PROJECT: K.T. Wiedemann

Business Park

REFERENCE: Channel realignment and re-design

As per your conversation this morning with Dick Linn, our client wishes to amend the design channel for that portion of a tributary to Four Mile Creek which crosses the northeast corner of the property being platted as K.T. Wiedemann Business Park. Enclosed are the re-design calculations along with the proposed re-alignment of the portion of the channel within K.T. Wiedemann. If you have any questions, please contact either Dick Linn or myself.

Typical Section

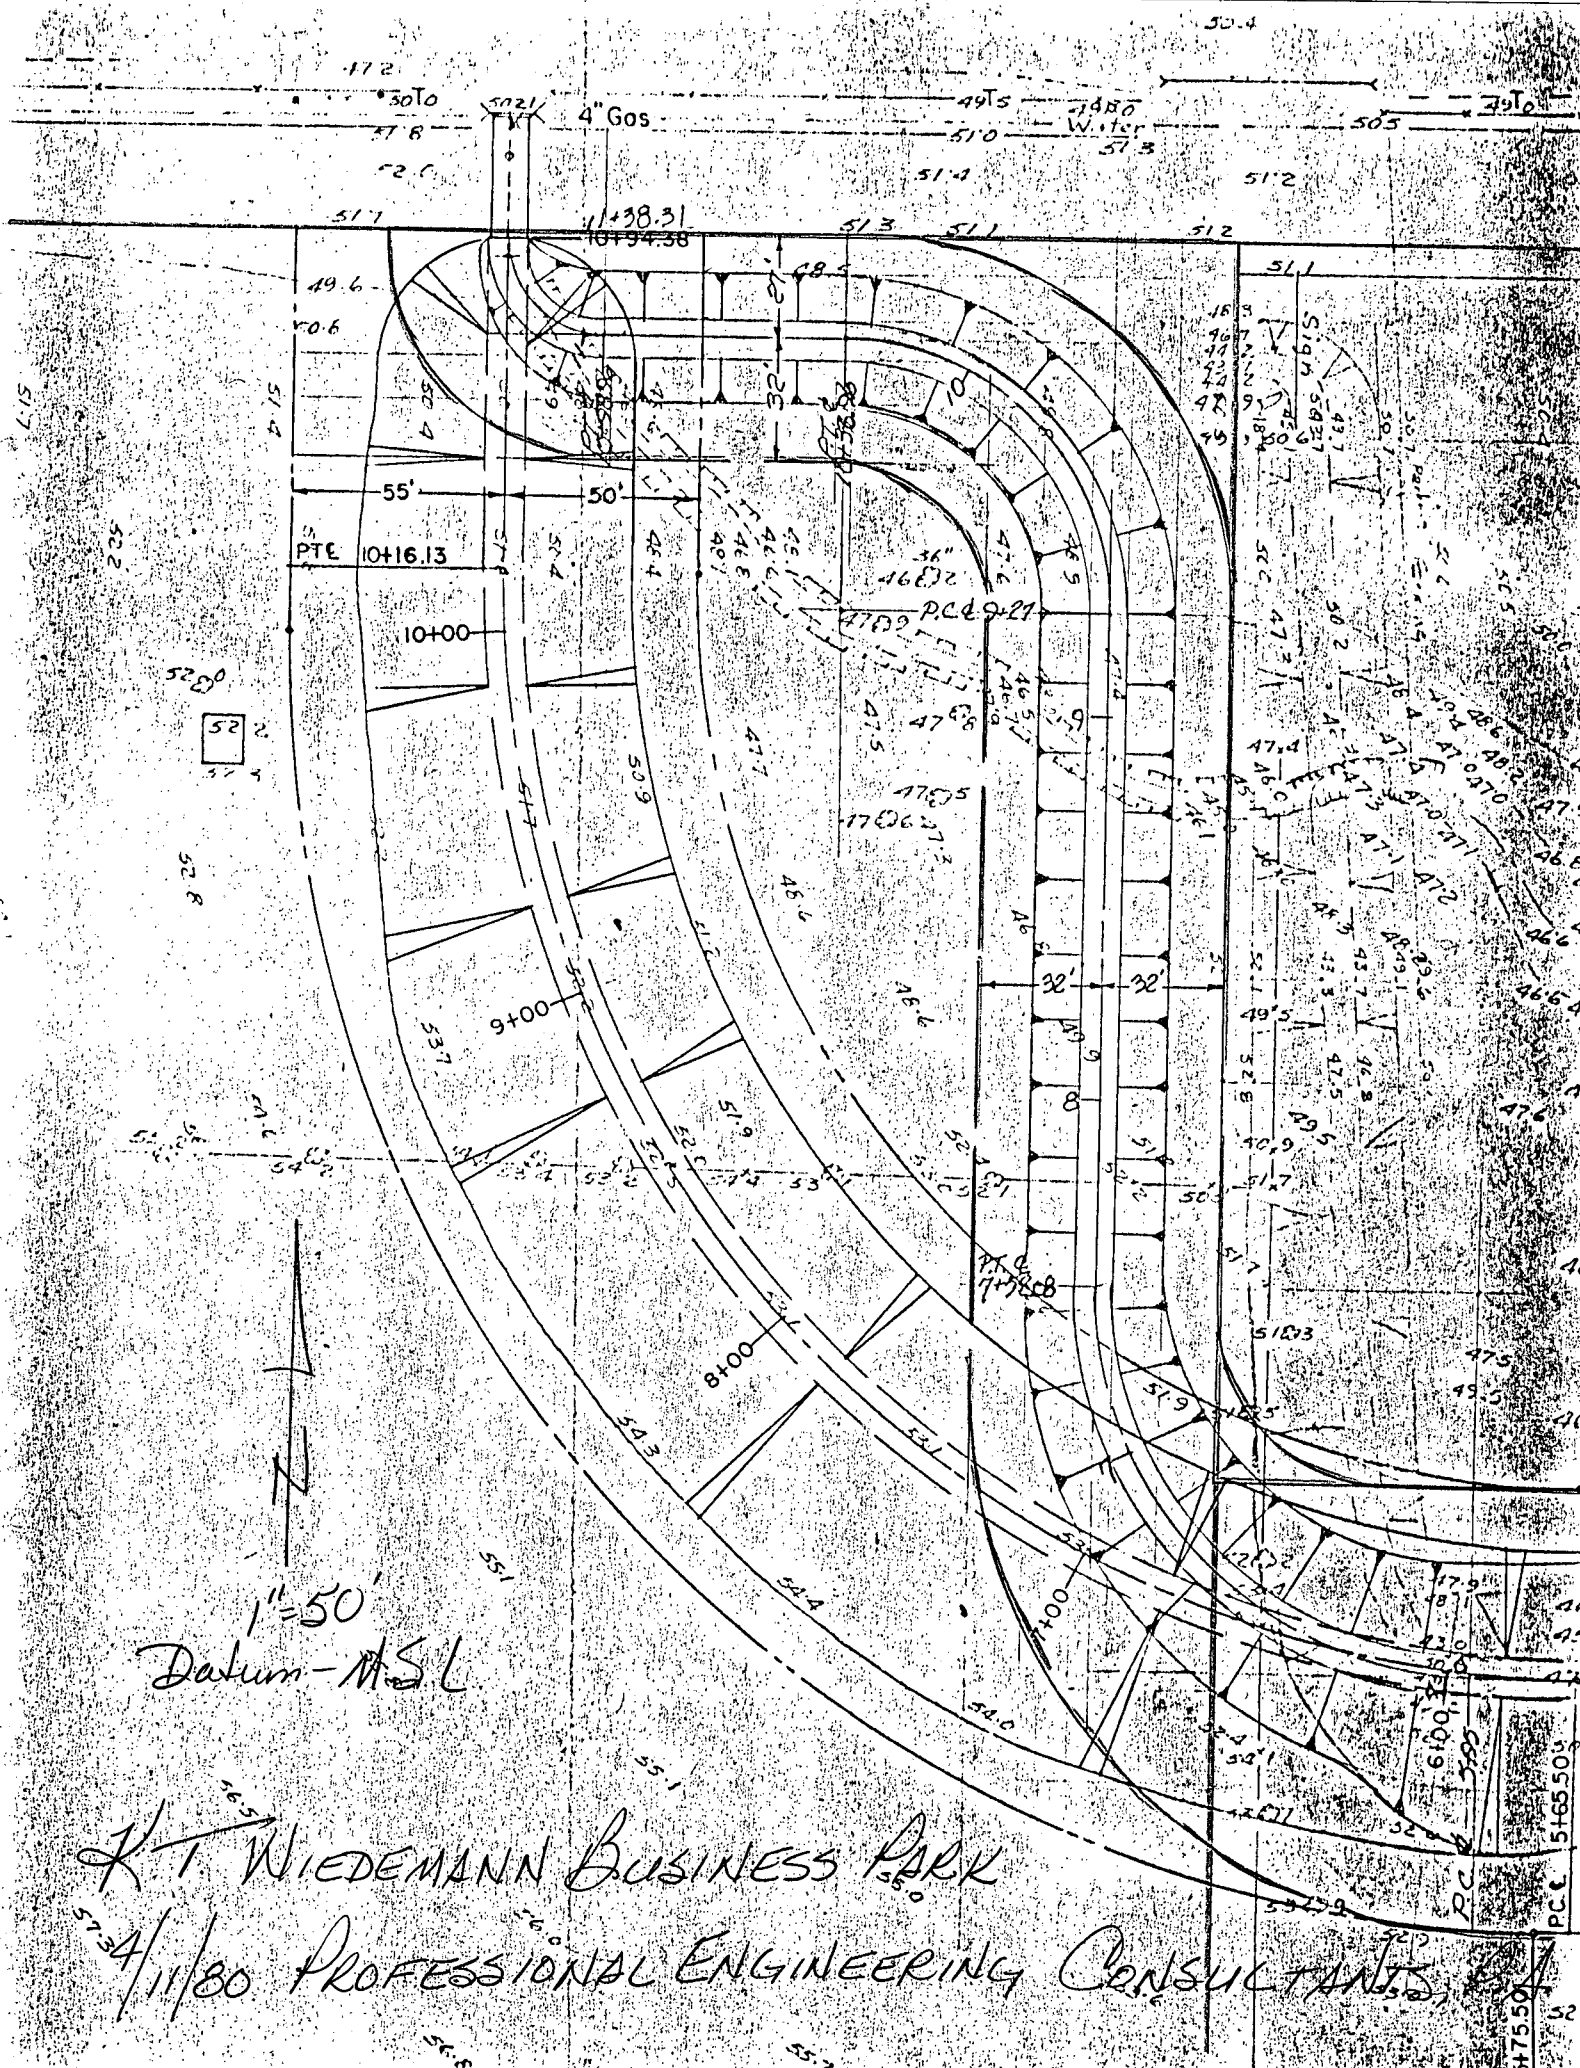
As per your conversation this morning with Dick Linn, our client wishes to amend the design channel for that portion of a tributary to Four Mile Creek which crosses the northeast corner of the property being platted as K.T. Wiedemann Business Park. Enclosed are the re-design calculations along with the proposed re-alignment of the portion of the channel within K.T. Wiedemann. If you have any questions, please contact either Dick Linn or myself.

Item CHANNEL RE-DESIGN

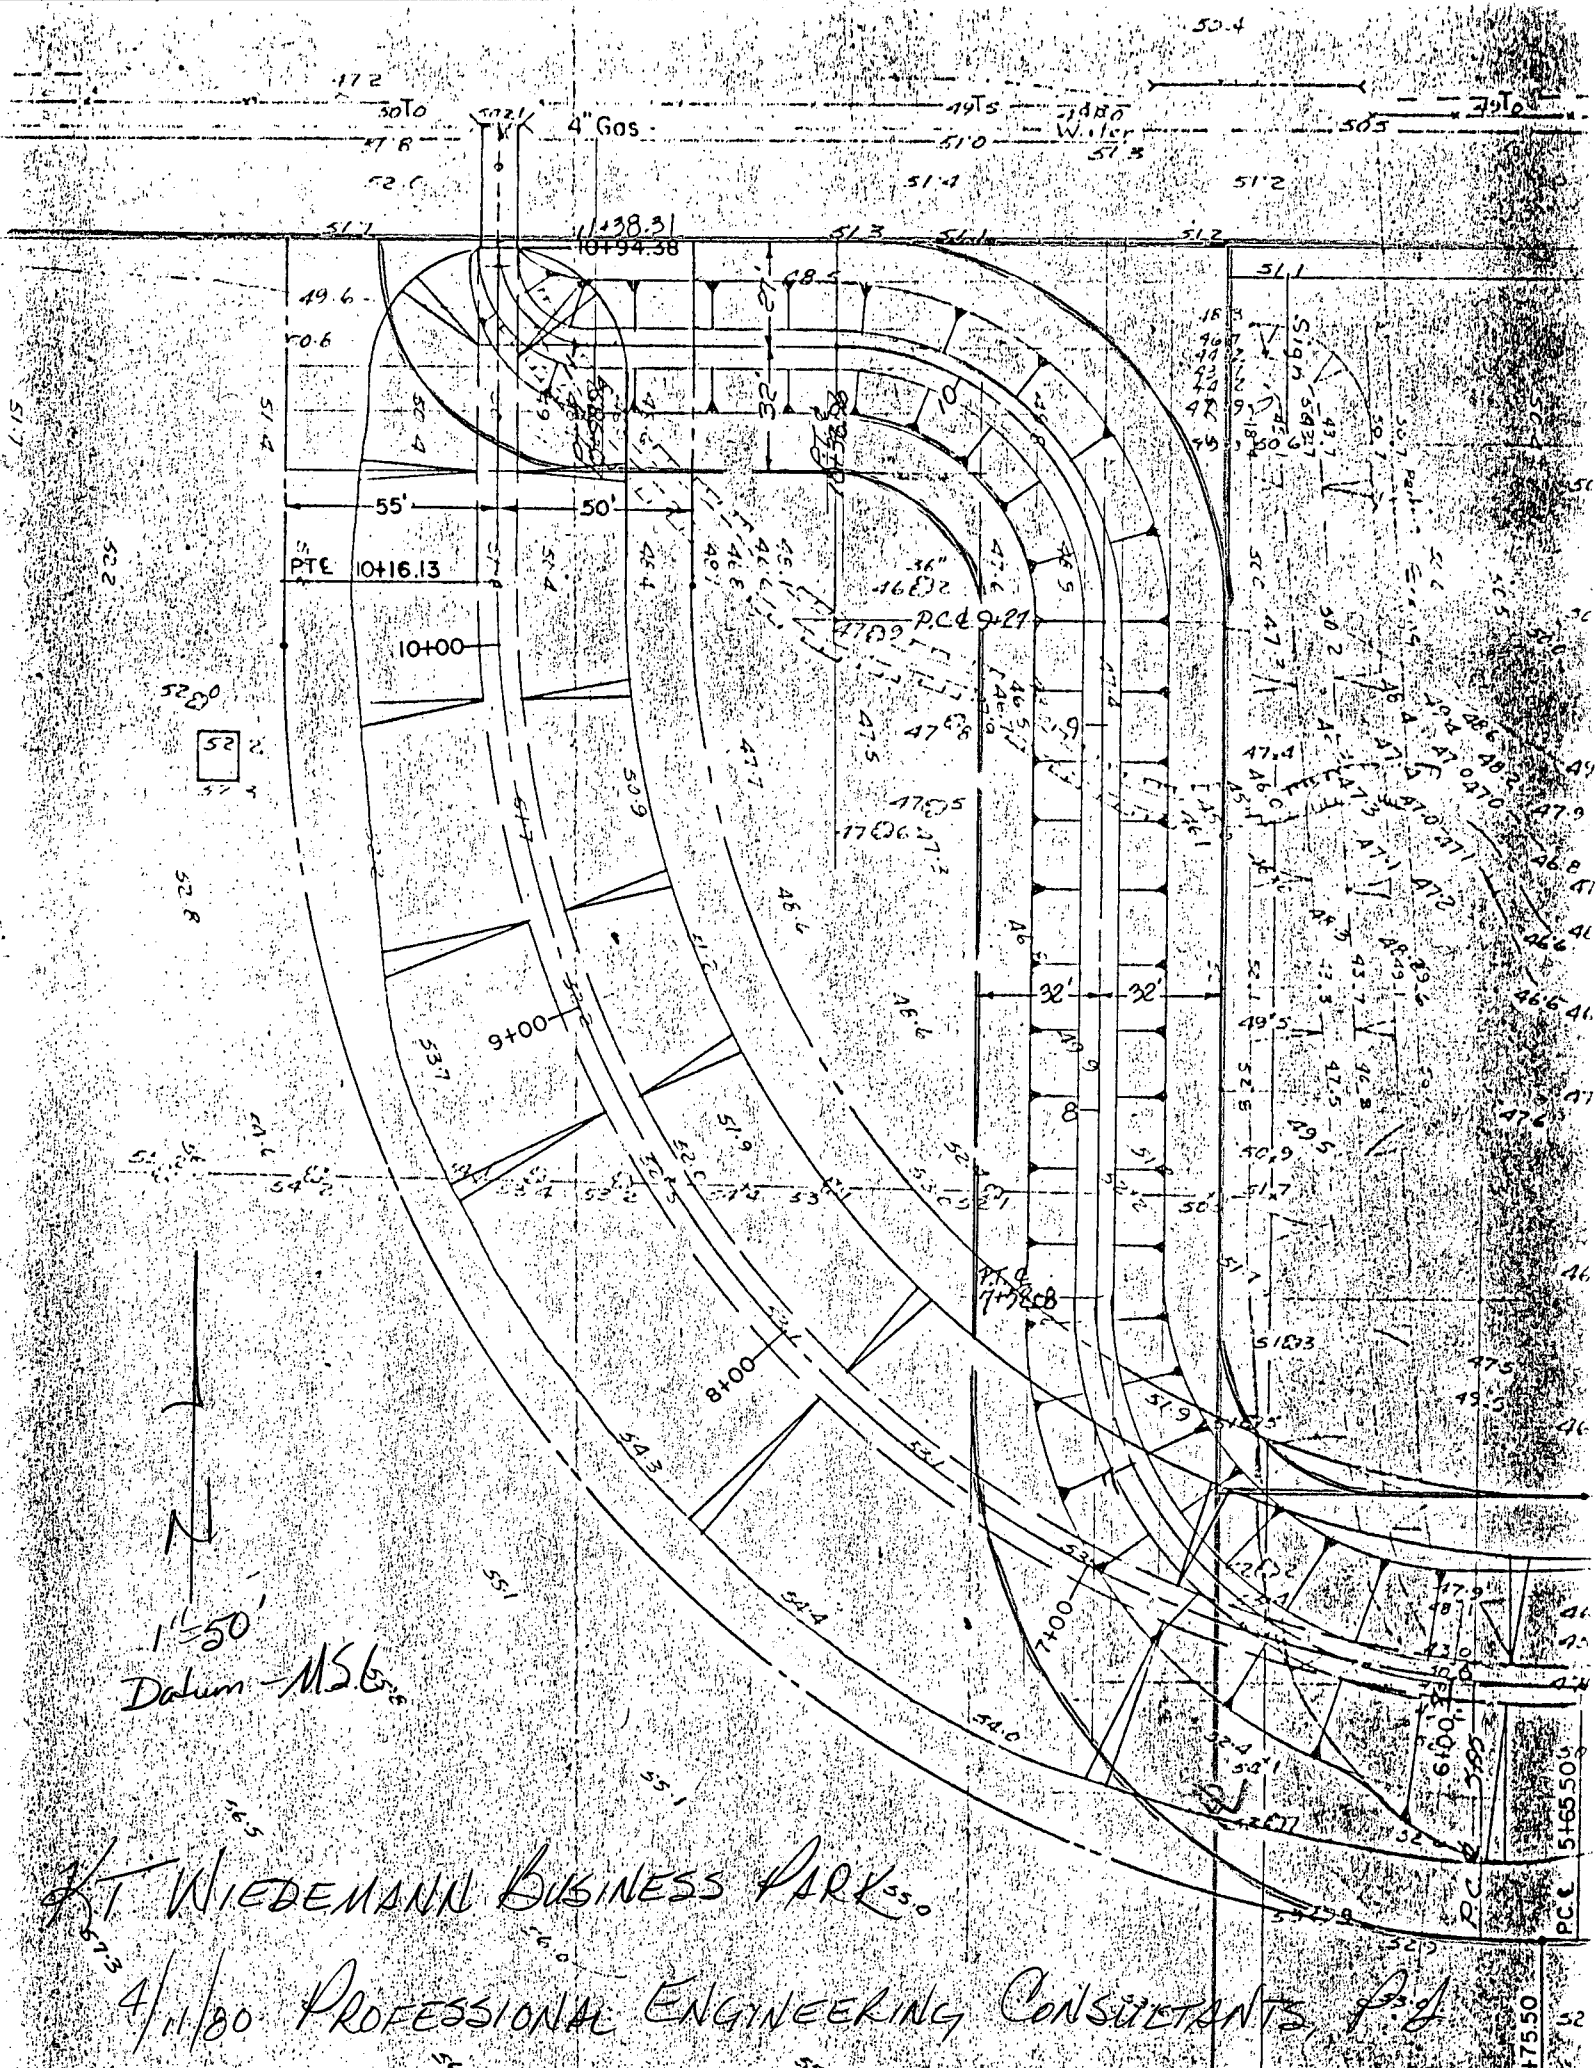
FLOOD CONTROL DESIGN CHANNEL

BOTTOM WIDTH 10 FT  
 SIDE SLOPES 4:1  
 CHANNEL SLOPE 0.346%  
 MANNING'S n 0.035 (GRASSED CHANNEL)  
 TOTAL DEPTH 7.00 FT  
 DEPTH OF FLOW (FOR 450 CFS) 3.93 FT  
 FREEBOARD 3 FT

PROPOSED DESIGN CHANNEL

BOTTOM WIDTH 10 FT  
 SIDE SLOPES 2:1  
 CHANNEL SLOPE 0.30%  
 MANNING'S n 0.015 (CONCRETE-LINED CHANNEL)  
 TOTAL DEPTH 6.00 FT  
 DEPTH OF FLOW (FOR 400 CFS) 2.93 FT  
 FREEBOARD 3 FT  
 VELOCITY 8.6 FPS
